This is to certify that City Of Portland/Hardcore Skate Parks marks
has permission to Build new concrete skate park on the former tennis court. SEP 30 2010
AT 91 Douglass St CE 066 A002001

From: "David Senus" <dsenus@woodardcurran.com>
To: "Jean Fraser" <JF@portlandmaine.gov>
CC: "Al Palmer" <APalmer@gorrillpalmer.com>, "Barbara Barhydt" <BAB@portland...>
Date: 9/14/2010 11:20 AM
Subject: RE: Updated Site Plans - Skate Park Area Grading & Drainage
Attachments: Rev skatepark plans.pdf, Sheet 3of9.pdf

DOUGHERTY FIELD
 IMPROVEMENTS
 SKATE PARK AREA
 GRADING & DRAINAGE PLAN

On September 16, 2010, the Portland Planning Authority approved a minor site plan for a SkatePark in Dougherty Field, Douglas Street and adjacent to St James Street, as submitted by the applicant and shown on the approved plans: SP-1B Rev 2; SP-1C Rev 2; SP-1D Rev 2; and SP-5D Rev 1 prepared by Hardcore Shotcrete Skateparks Inc; and *Skate Park Area Grading & Drainage* sheet 3 of 9 dated 9.14.2010 and *Landscape Plan* sheet 5 of 9 dated 9.03.2010 prepared by Woodard & Curran, with the following conditions:

SP-1B
 9078
 AS NOTED
 M. LEONE
 J. HETTINGER

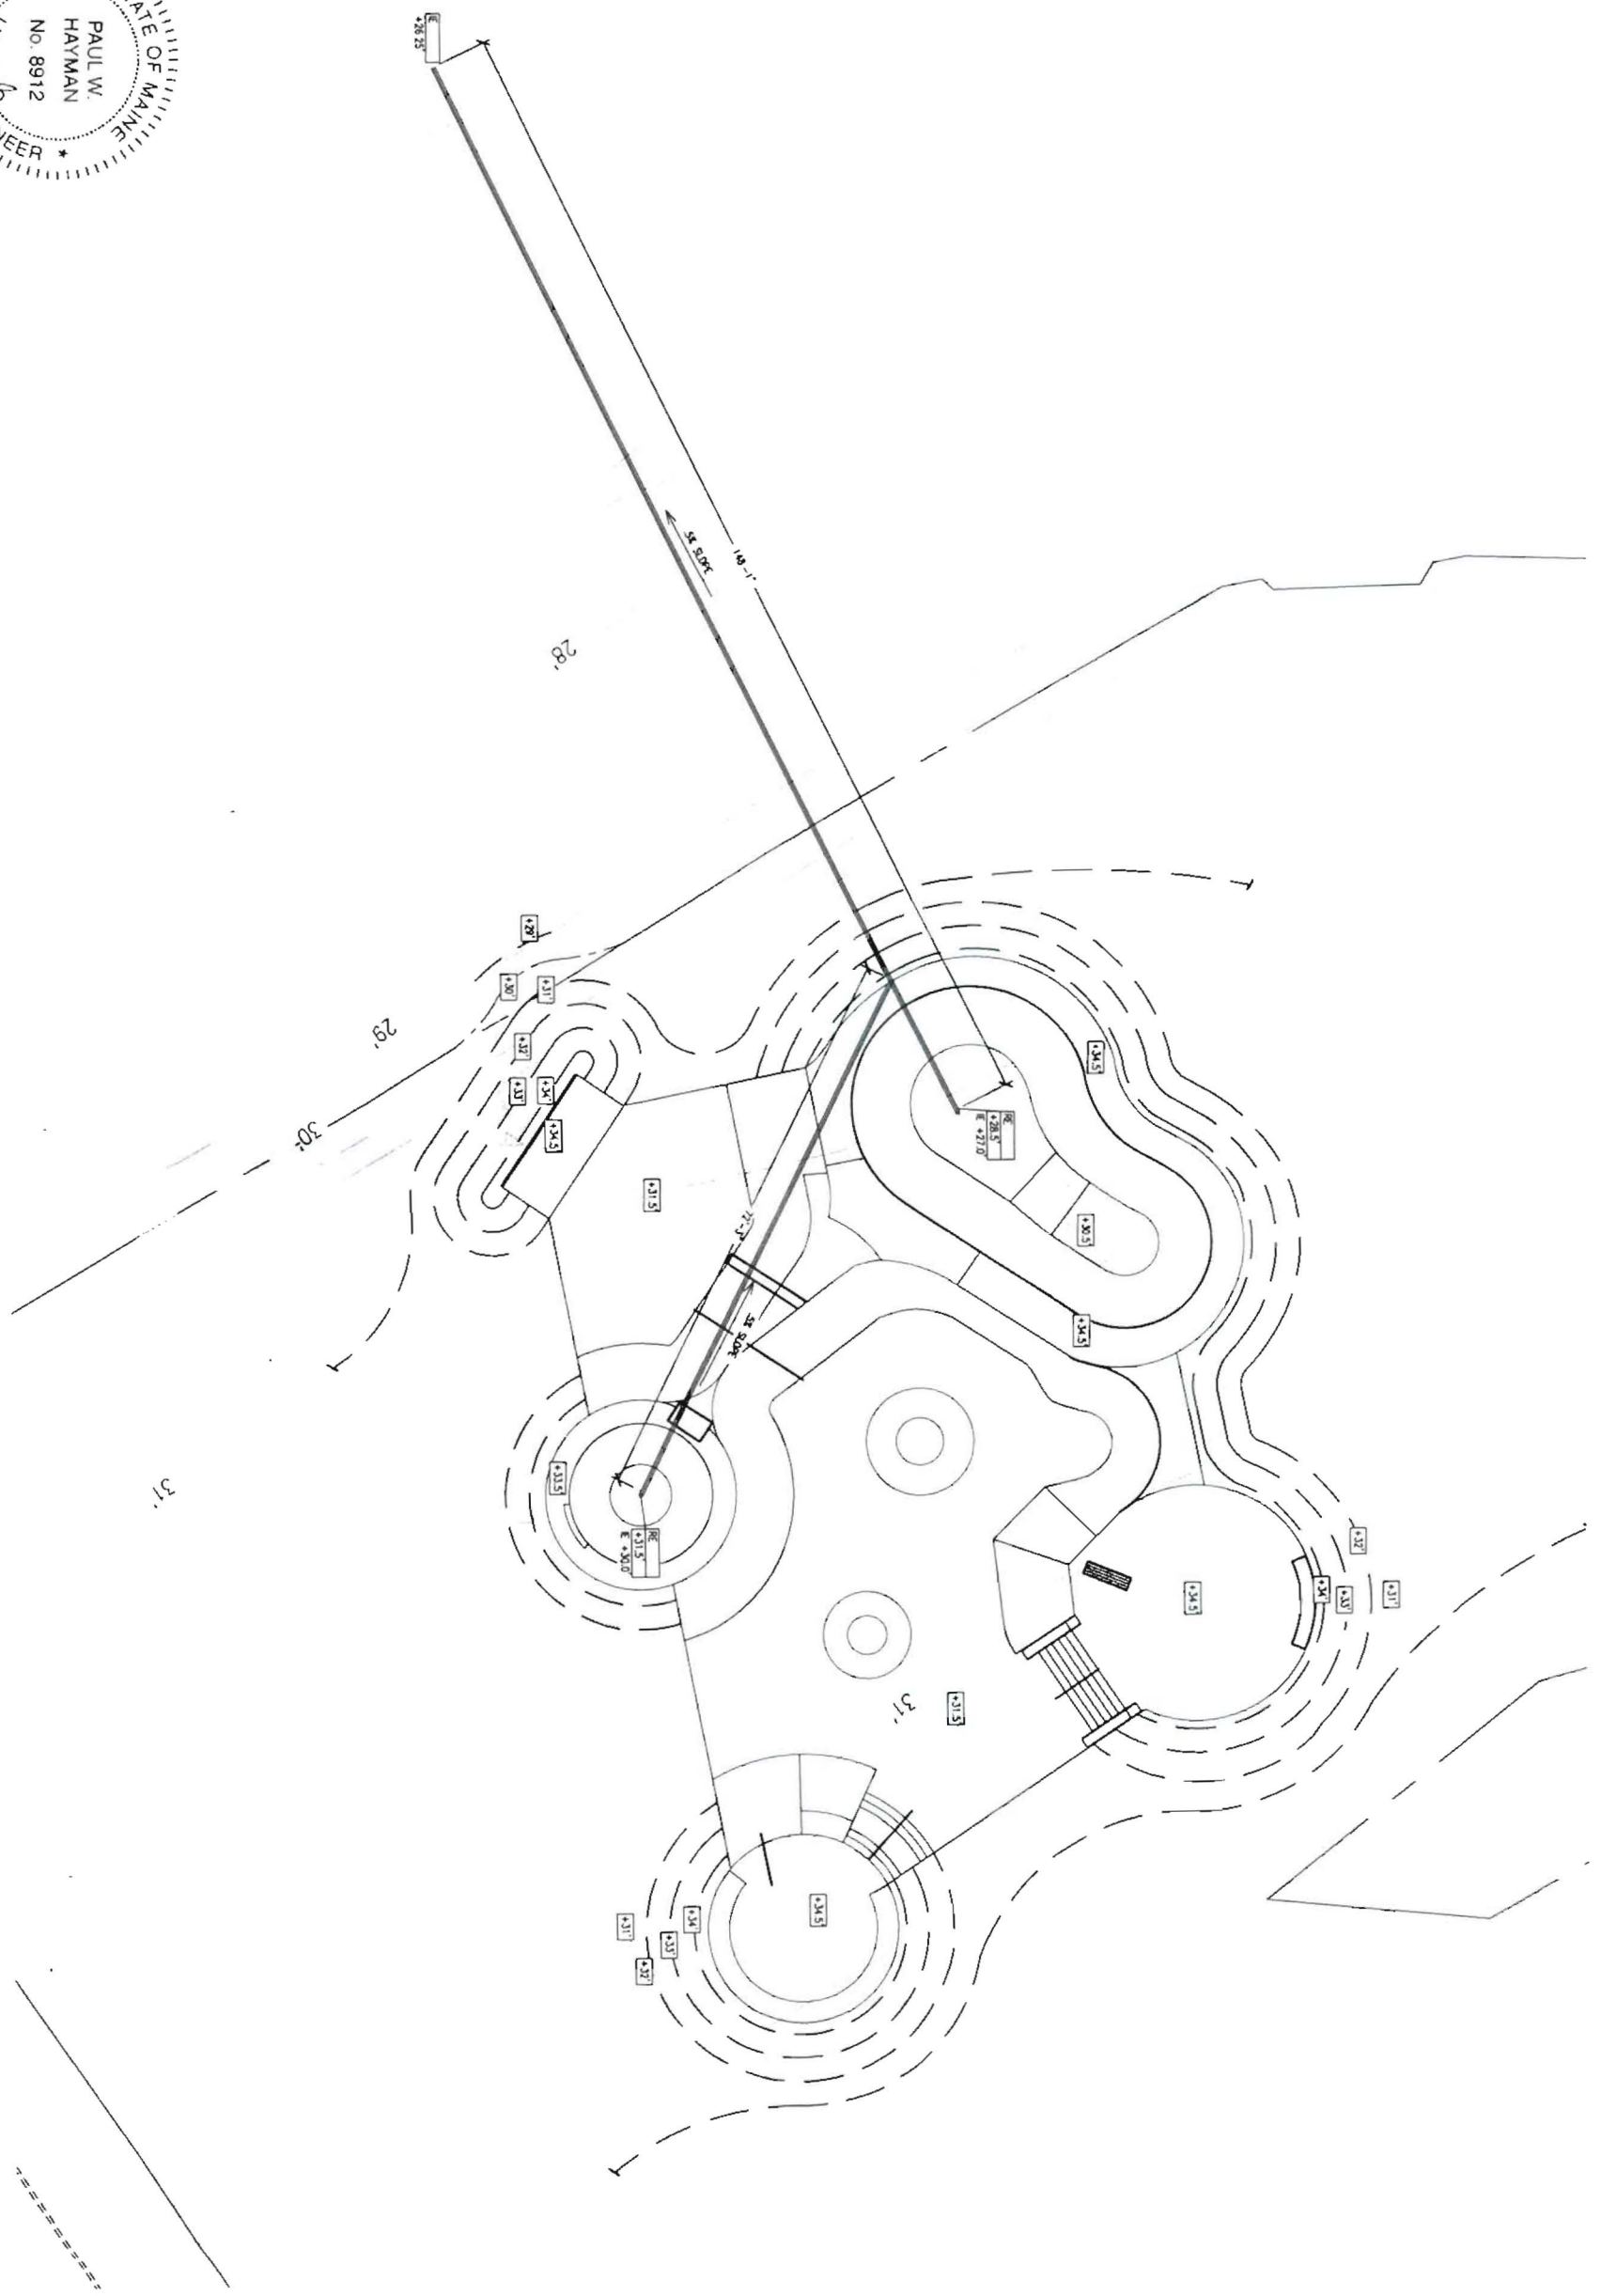
- >SP-1B - Updates to drainage to match W&C/RSL plan; addition of perimeter erosion control barrier; addition of diversion berm uphill of construction; addition of underdrains below skatepark
- >SP-1C - Iso 3d view of underdrain and drainage pipes for skatepark
- >SP-1D - Detailed spot grades within skatepark
- >SP-5D - Additional detail sheet

1. That the siltation barrier around the SkatePark site shall be installed prior to any vehicle access or regarding on the site; and
2. That the grading shall be as shown on Drawing SP-1B Rev 2 and SP-1D Rev 2, to be ensured by inclusion of these grading plans in the contract documents, and by a professional engineer confirming during construction that the as-built grades are correct, so that there is no ponding water on any of the concrete work upon completion; and

1 SKATEPARK ELEVATIONS
Scale: NONE

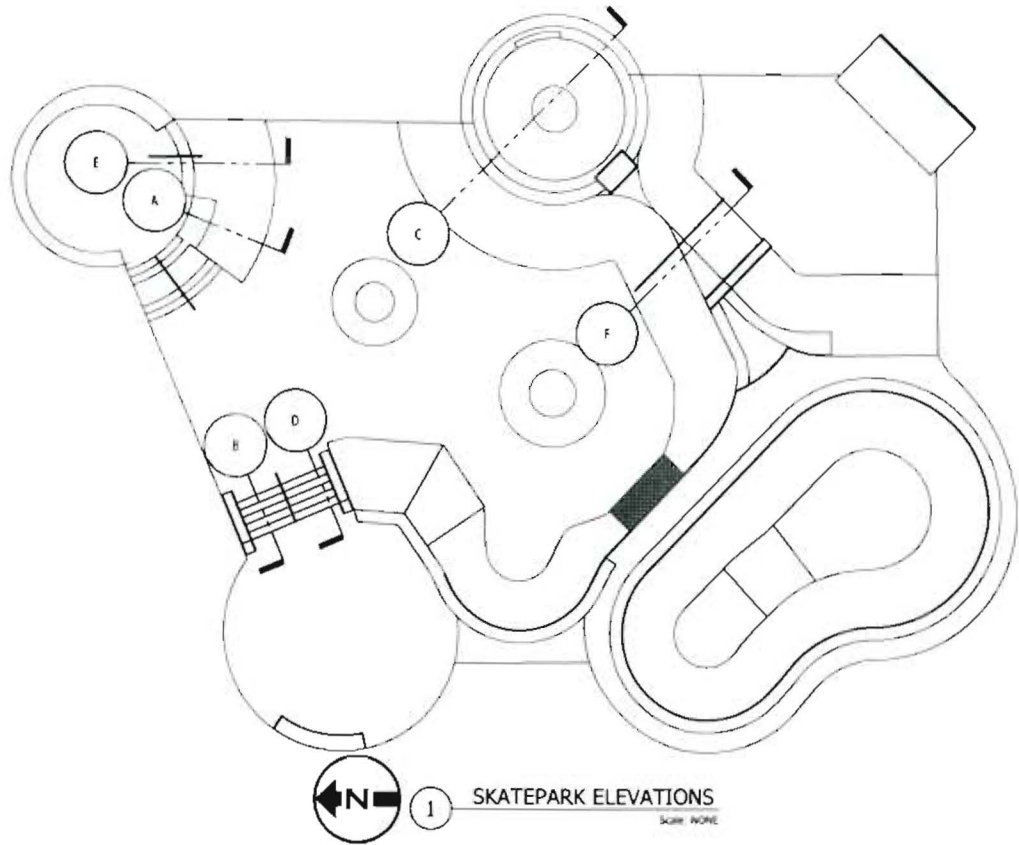
The only element of the skatepark that sits higher than a couple of feet is the Deckless Quarter Pipe, which sits 5-ft high, as shown on Sheet SP-4. Recommended special inspections for this element would be the following:
